# Brighton Council

## NOTICE OF MEETING

## **5.1 APPLICATION UNDER BRIGHTON INTERIM PLANNING SCHEME 2015 DA 2019/00222 – LOT 201 CALM PLACE, OLD BEACH MULTIPLE DWELLINGS (4):**

Type of Report	Planning Authority – For Decision
Application No:	DA 2019/00222
Address:	Lot 201 Calm Place, Old Beach
Proposal:	Multiple Dwellings (4)
Zone:	General Residential Zone
Representations:	Three (3)
Discretions:	<ol style="list-style-type: none"><li>1. Building Envelope</li><li>2. Private Open Space</li><li>3. Sight Distance at Accesses</li><li>4. Stormwater Drainage and Disposal</li><li>5. Buildings and Works within a Waterway and Coastal Protection Area</li><li>6. Buildings and Works within a Waterway and Coastal Protection Area</li><li>7. Coastal Inundation High Hazard Area</li><li>8. Coastal Inundation Medium Hazard Area</li><li>9. Coastal Inundation Low Hazard Area</li><li>10. Riverine, Coastal Investigation Areas, Low, Medium, High Inundation Hazard Areas</li><li>11. Riverine, Coastal Investigation Areas, Low, Medium, High Inundation Hazard Areas</li></ol>
Attachments:	A – Advertised documents (See pages 40 -88) B – Representations (x3)

**1941 A04 - E**  
**LANDSCAPE PLAN**

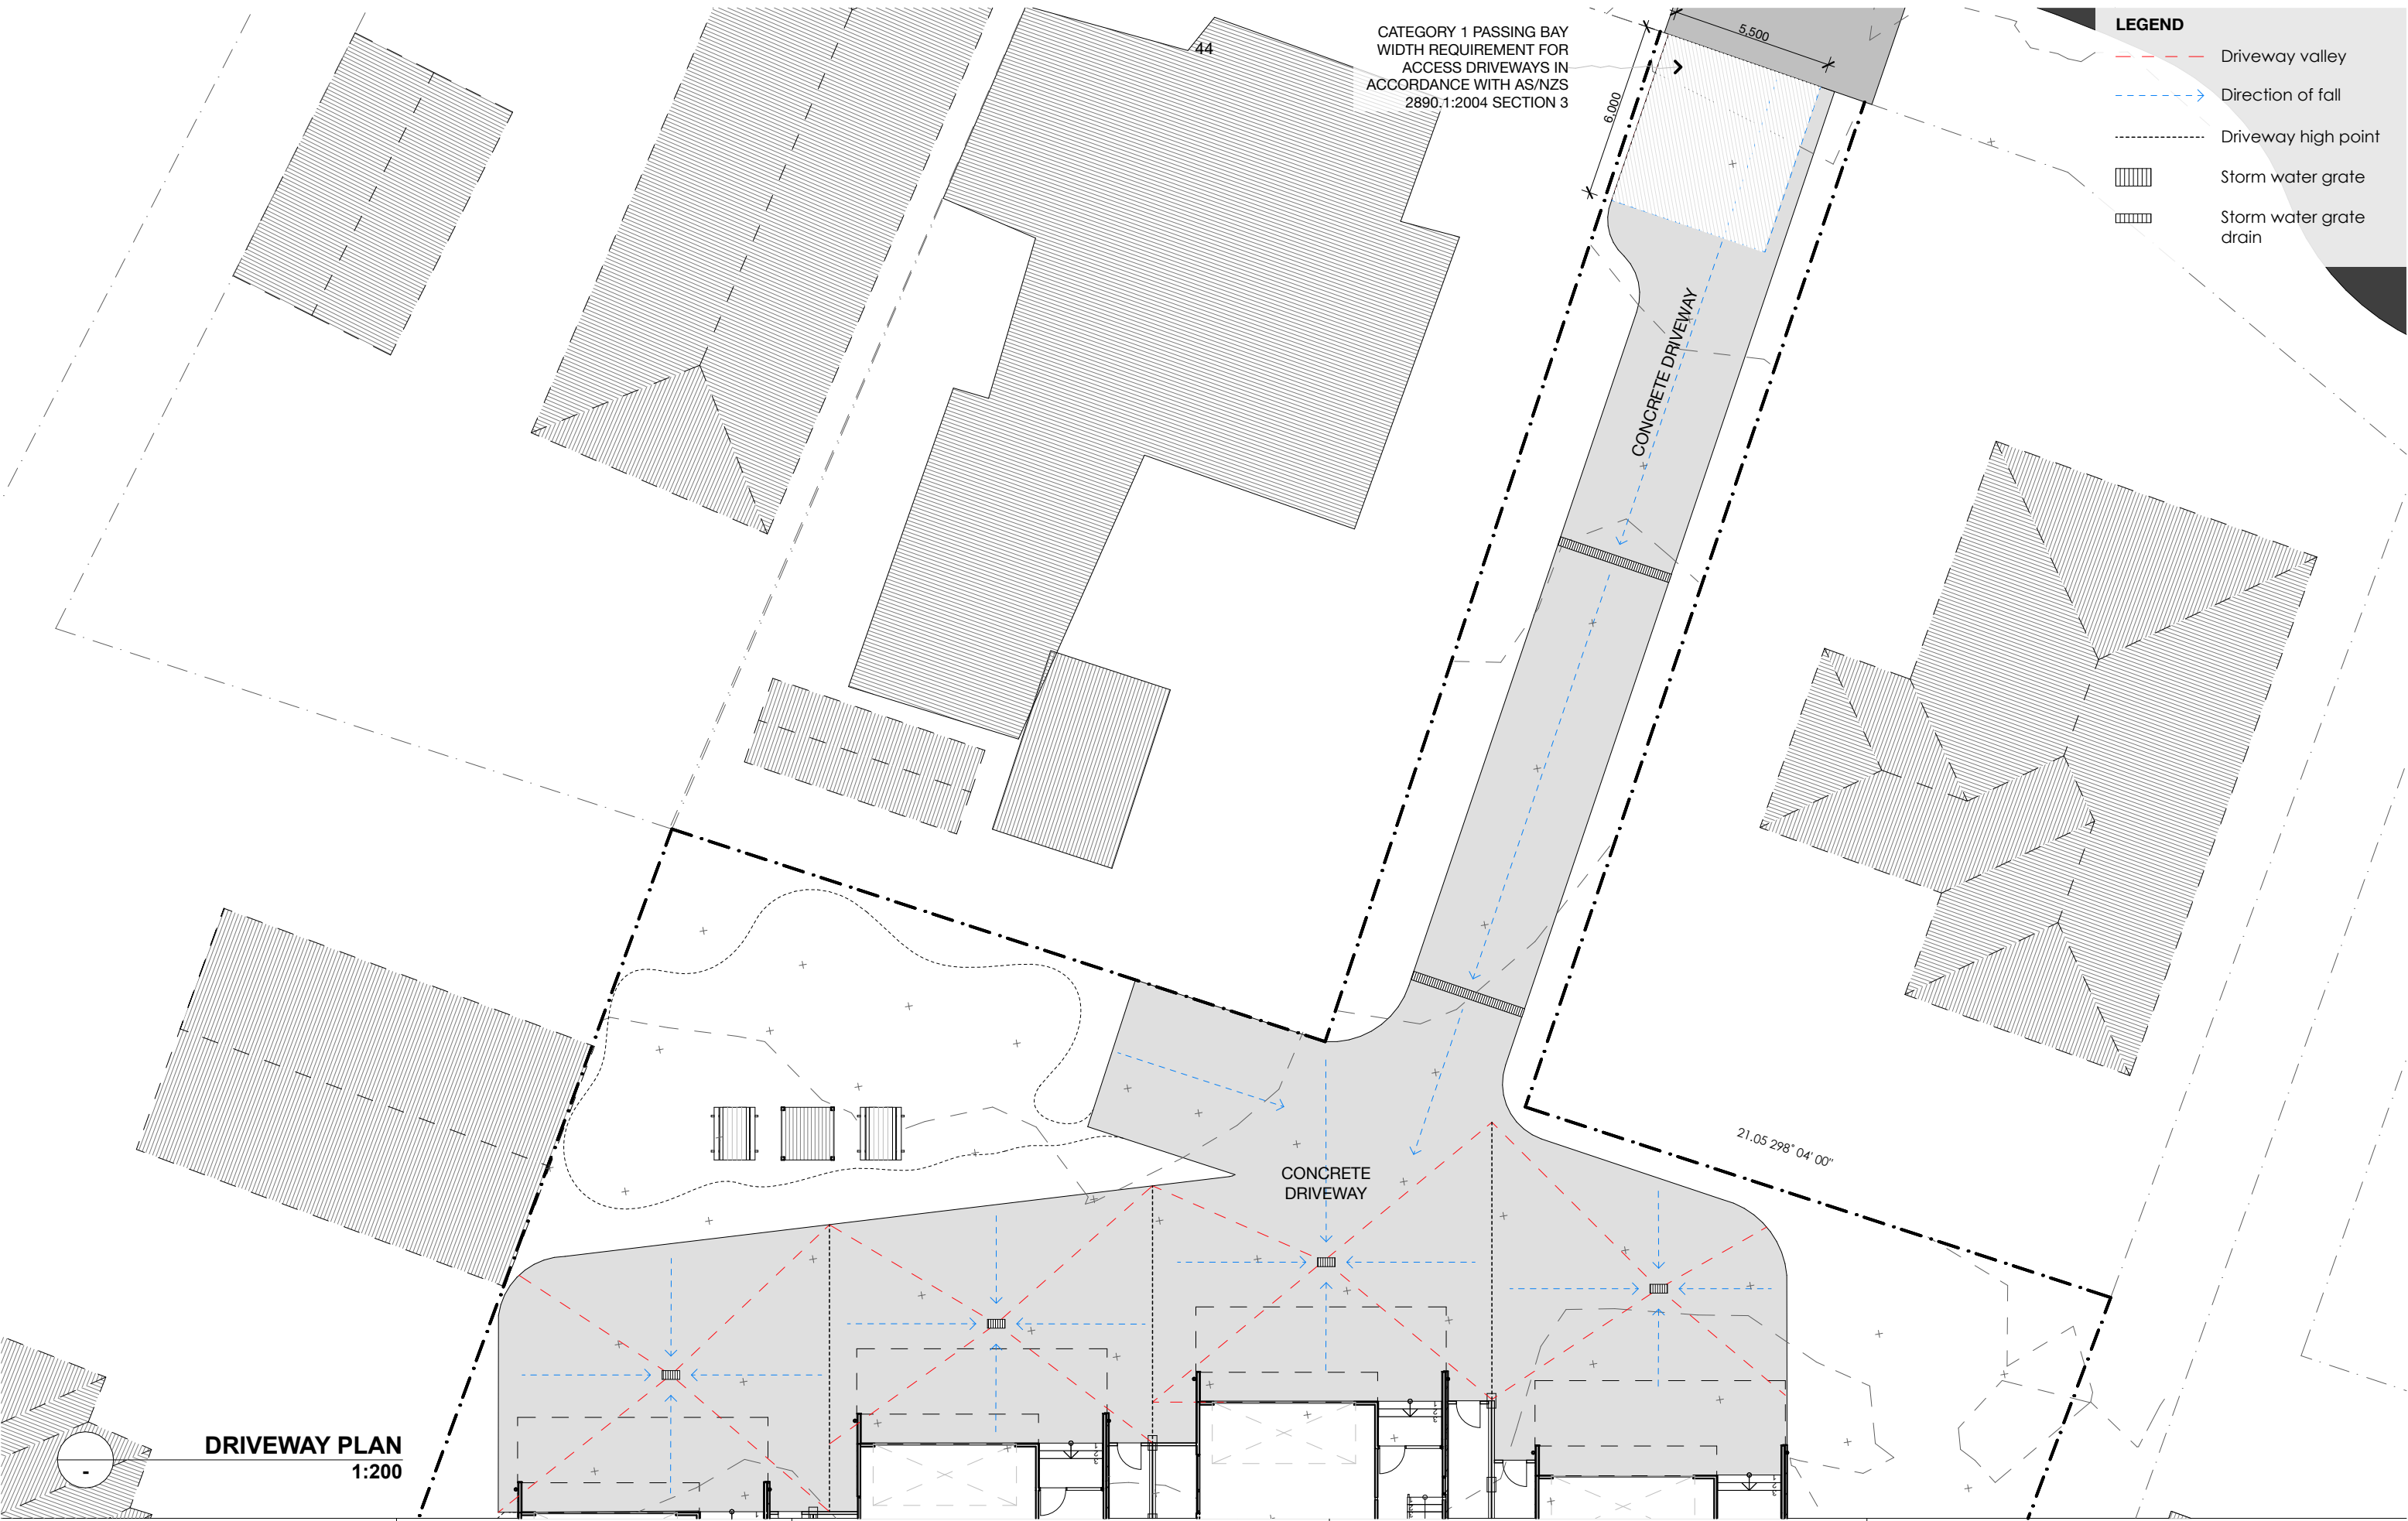
- 8.5.10 In addition, the landscaping plan proposes a mix of vegetation to be planted, including screening trees which will - once established - reduce the visual impact from adjoining properties. A condition requiring mature feature trees to be a minimum height at the time of planting is recommended to accelerate this outcome.

- (8) Before any work commences submit an amended landscape plan prepared by a suitably qualified person for approval by Council's Manager Development Services. The amended landscape plan must include:
  - (a) A survey of all existing vegetation to be retained and/or removed.

- (b) An alternative species for “t6 Luscious” is to be planted in the northern and north eastern corners of the site, with a species that does not exceed 9m in height.

- (c) The areas to be landscaped, including landscaping along the access strip with planting to a maximum height of 1.5m.
  - (d) Feature trees (i.e. t6 Luscious) and alternative species where applicable must be a minimum of 1.5mH at the time of planting.

**1941 A09 - E  
SHADOW DIAGRAM 02**

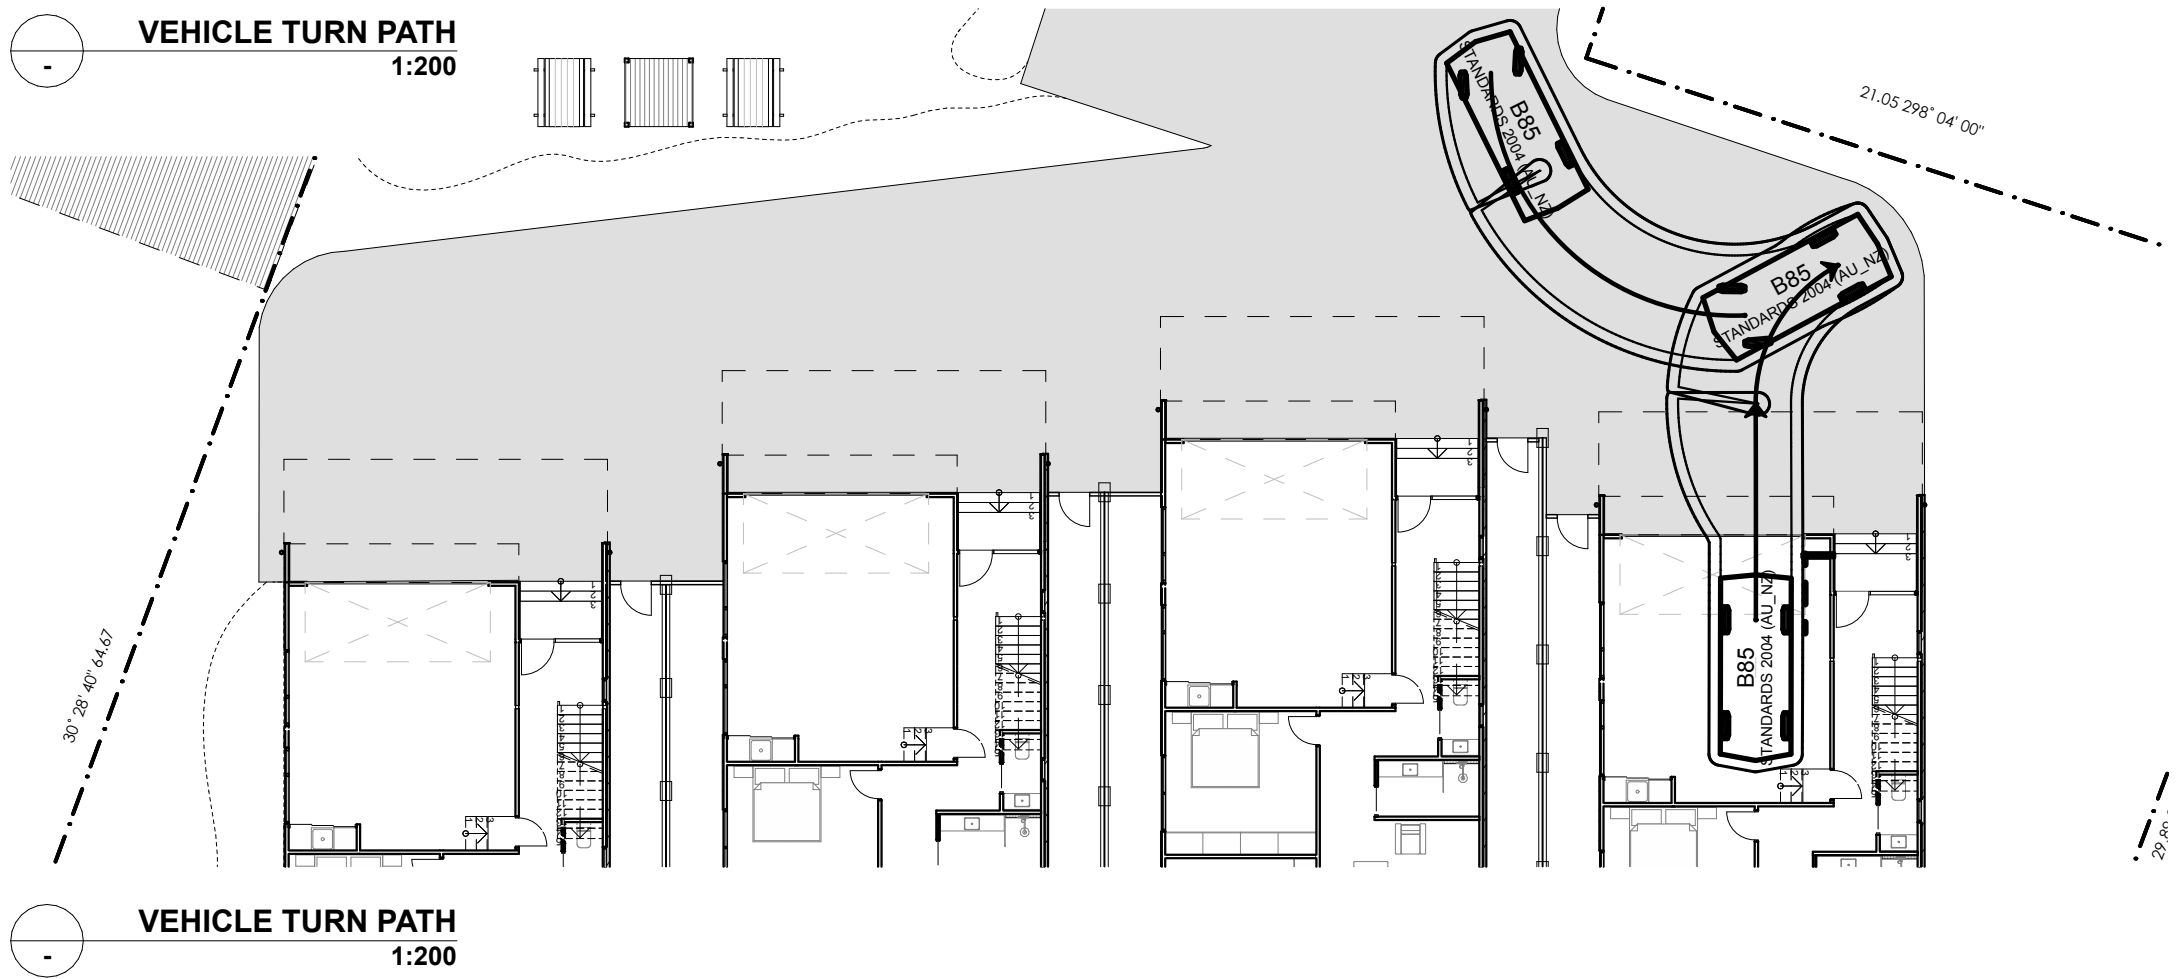
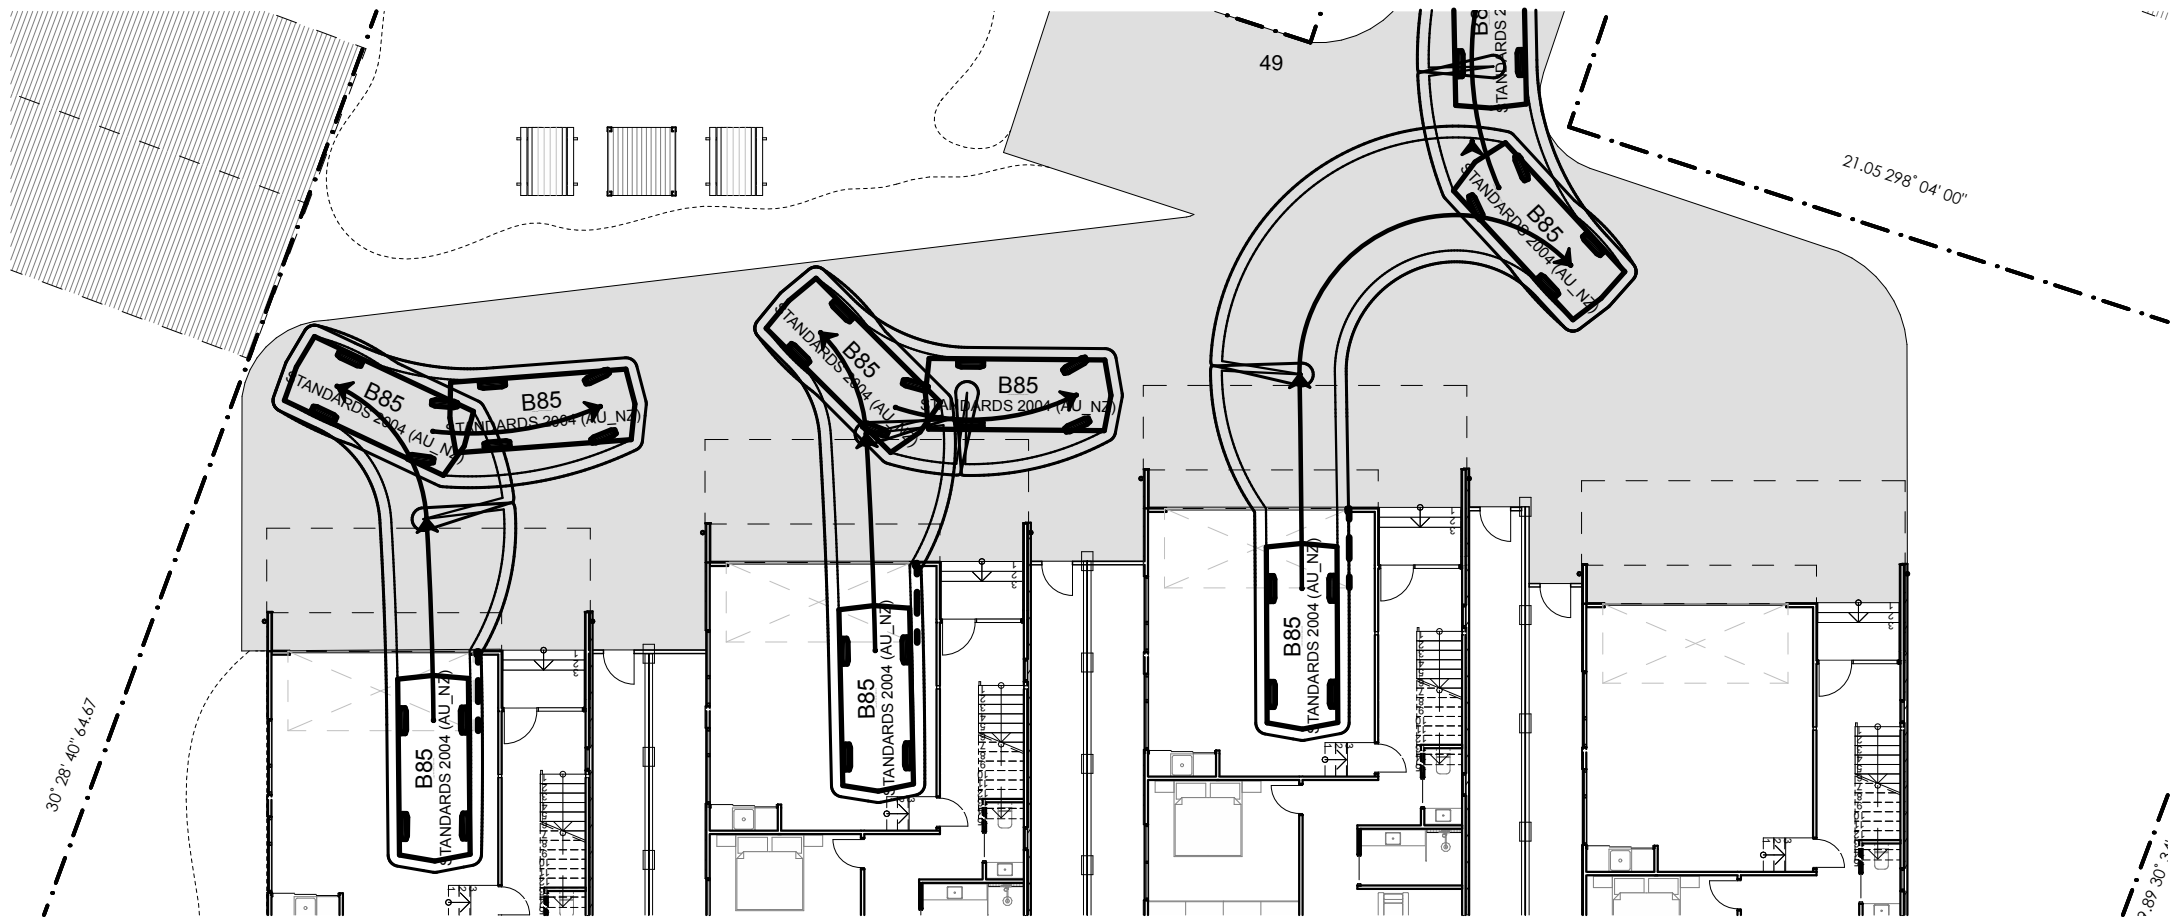
- 8.5.5 As shown in figure 4 below, the proposed units will be located to the south and south east of existing dwellings at 16, 20 and 26 Calm Place.
- 8.5.6 Shadow diagrams (refer sheets A08E and A09E) submitted in support of the development application show that there will be no overshadowing impact on either habitable rooms or private open space of adjoining properties.

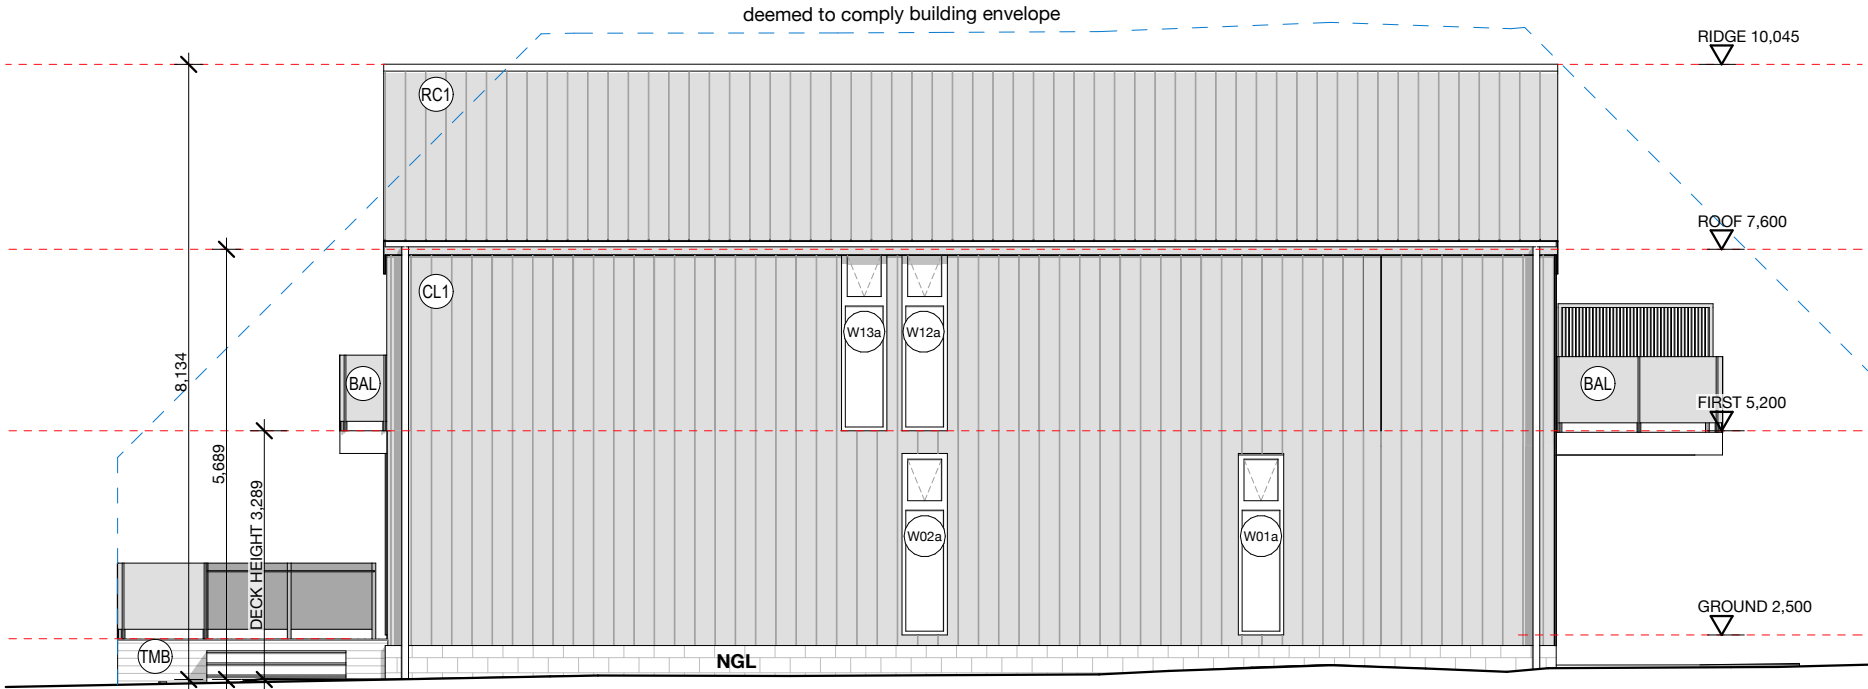
8.5.4 The dwellings are each two storeys, with a maximum height of 8.186m above natural ground level (refer sheet C05 E), which is less than the maximum building height permitted by Section 10.4.2 A3. However, reliance on the Performance Criteria arises in relation to Townhouse 01, where the total height of the building is 8.134m, and setback from the rear boundary is 4m. The south-eastern corner of the dwelling protrudes outside the permitted building envelope where the envelope angles internally by 45 degrees (refer east elevation, sheet A16 – E).
